SUBJECT: Responds to NRC request for addl info re unit 3 reactor building post-tensioning sys sixth surveillance.

Subject: Duke Power Company
Oconee Nuclear Station, Unit 3
Docket No. 50-287
Reactor Building Post-Tensioning System
Sixth Surveillance
Request for Additional Information

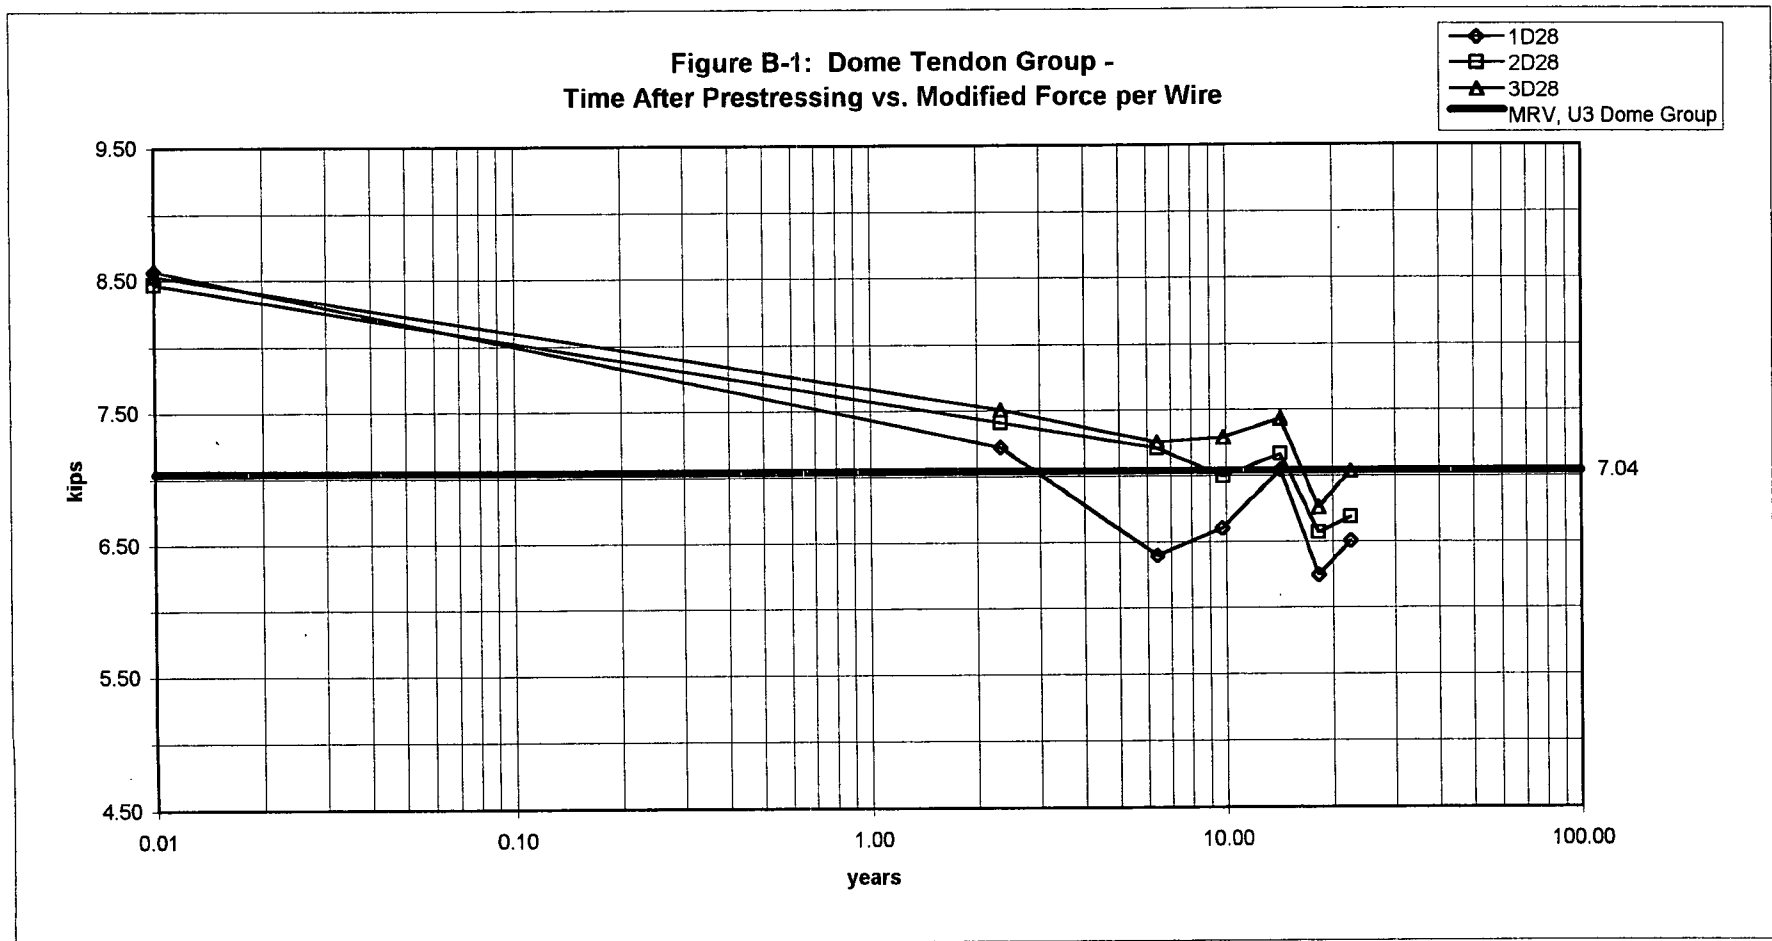
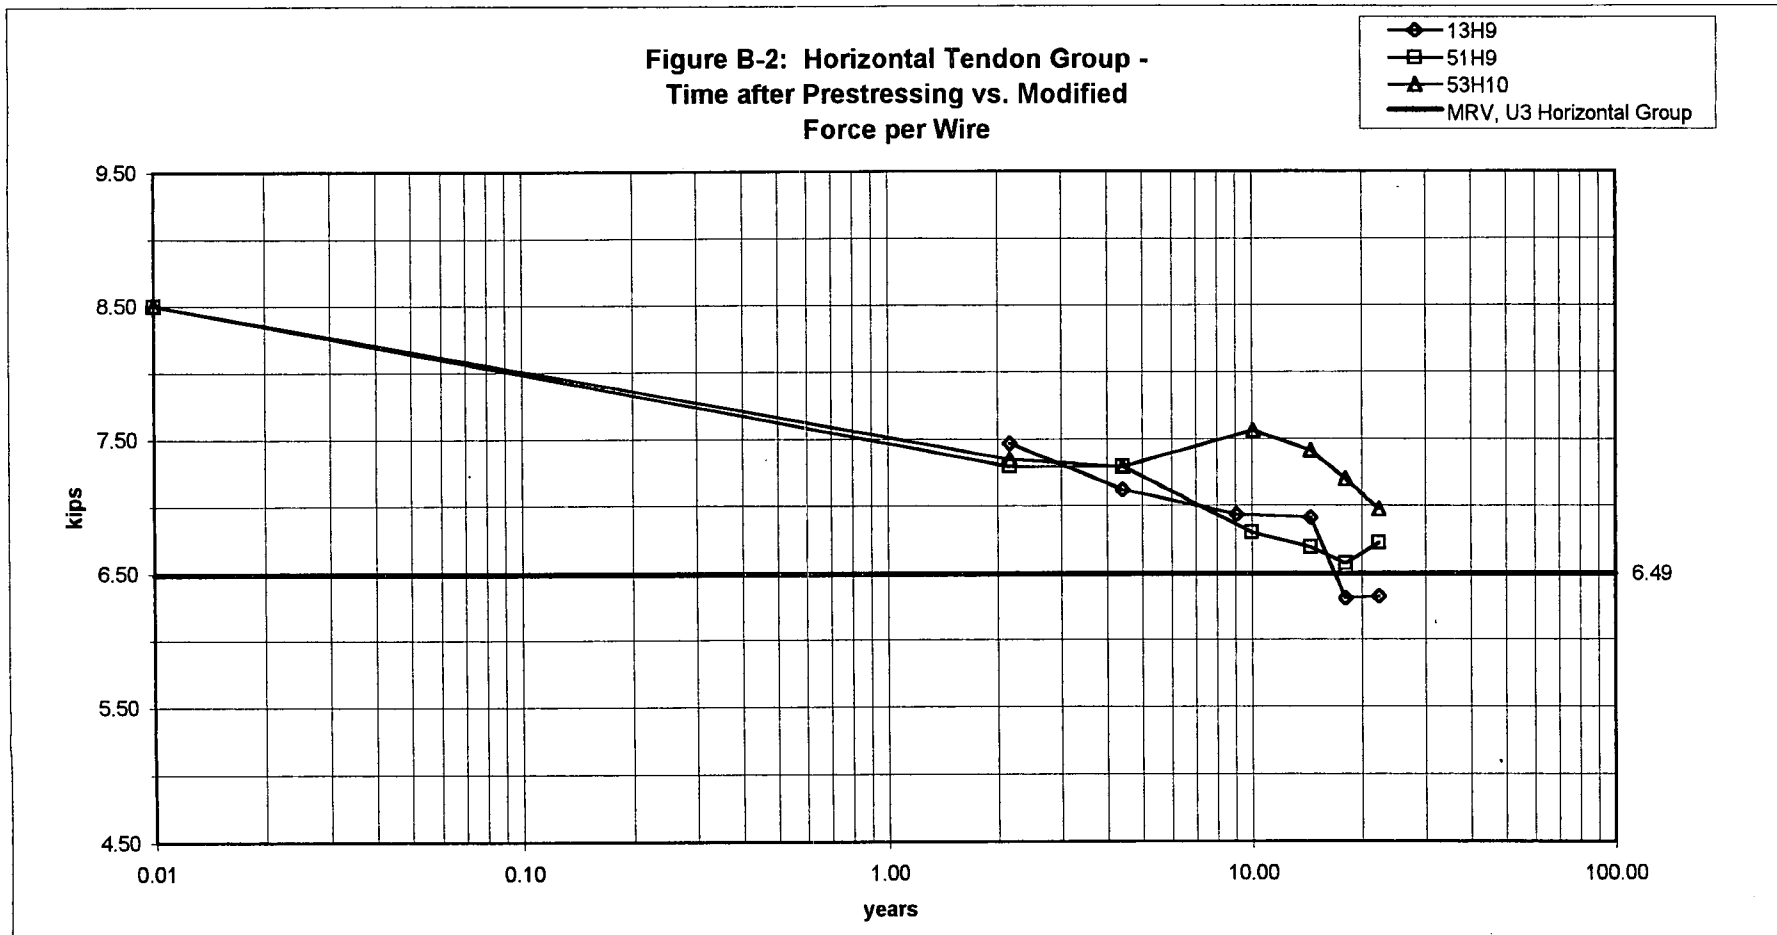
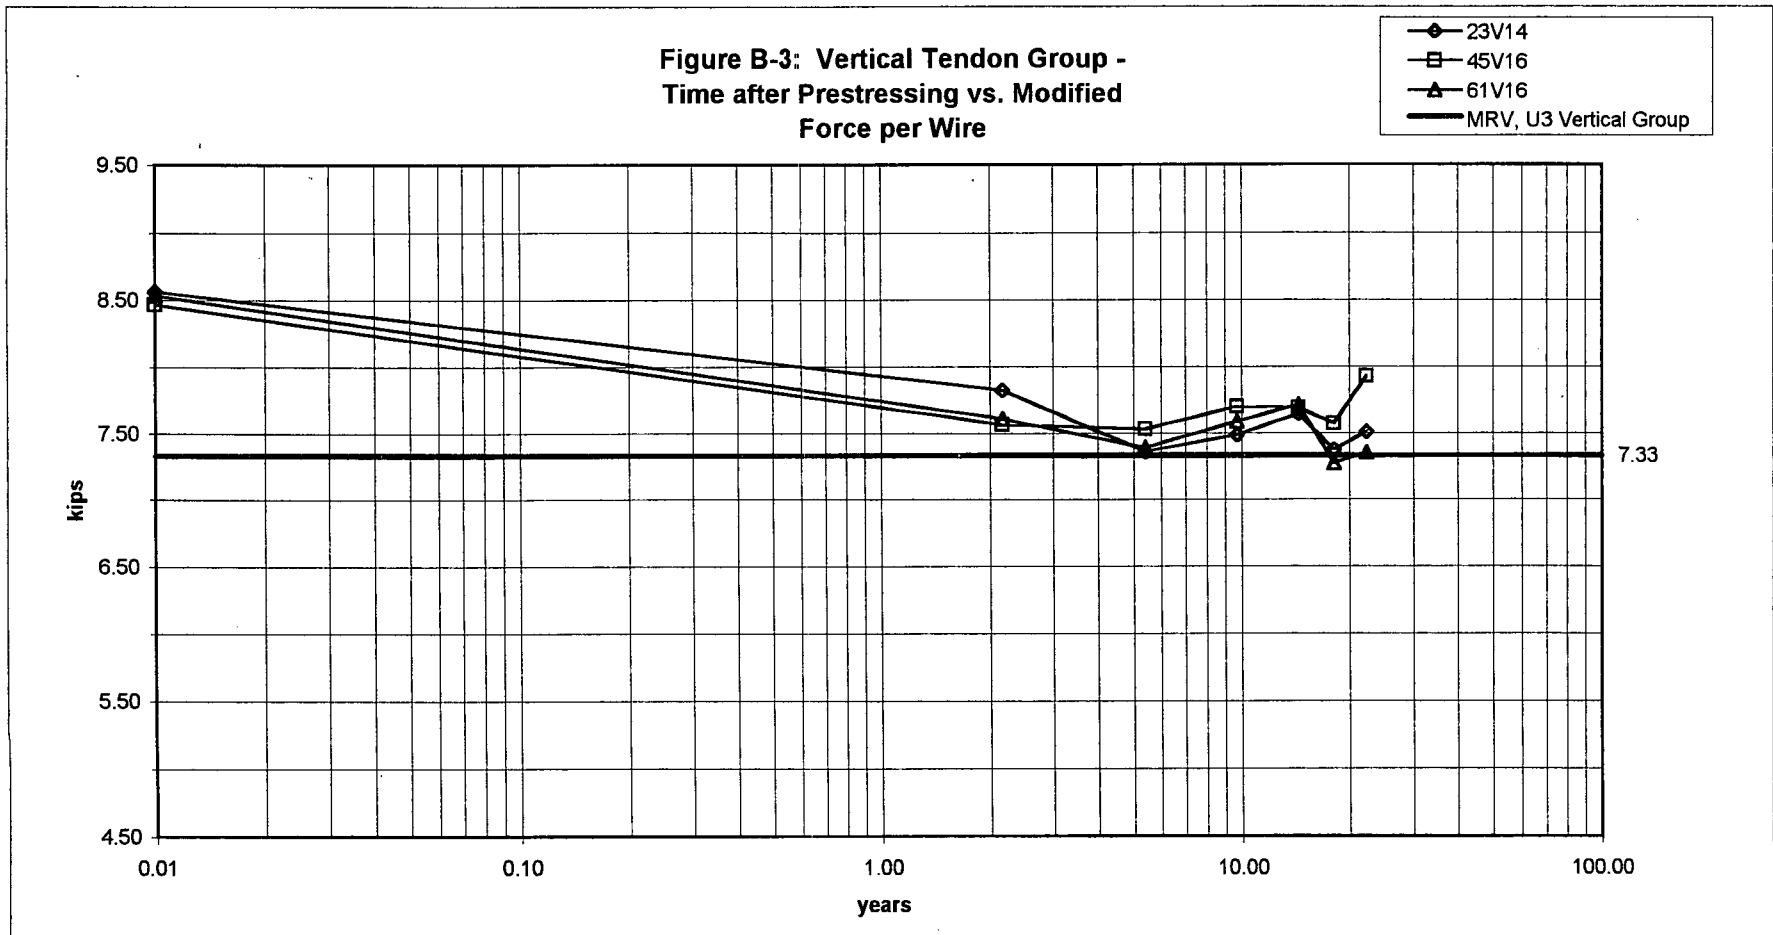
NRC Request #1b, Plot all lift-off force data (i.e., individual data obtained without averaging or taking mean values) on a graph similar to that shown in Figure 2 of Regulatory Guide (RG) 1.35.1 and include the minimum required value (MRV) identified for each group of tendons. Perform a regression analysis for each group of tendons on the basis of the plotted data to establish the trend of the prestress force.

Appendix B contains time versus lift-off force plots for all tendons inspected on Oconee Nuclear Station, Unit 3. Plotted lift-off forces are the modified values as directed per NRC request 1a. Minimum required value (MRV) for the respective tendon group - dome, horizontal, and vertical - is also shown on each plot. Plots were performed using Microsoft Excel[®], Version 5.0.
